**FINAL DRAINAGE REPORT
FOR
PAINT BRUSH HILLS
FILING 13E**

JULY 2018

PCD Project No. SF-18-xxx

INLET IN A SUMP OR SAG LOCATION

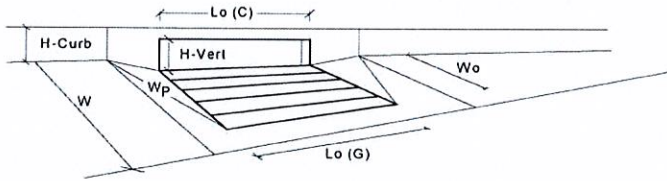
The narrative and drainage map both note 12' inlet. Verify. If the requirement was for a 15' inlet, the developer will need to replace.

Removed as narrative and flow are consistent with previous report / design.
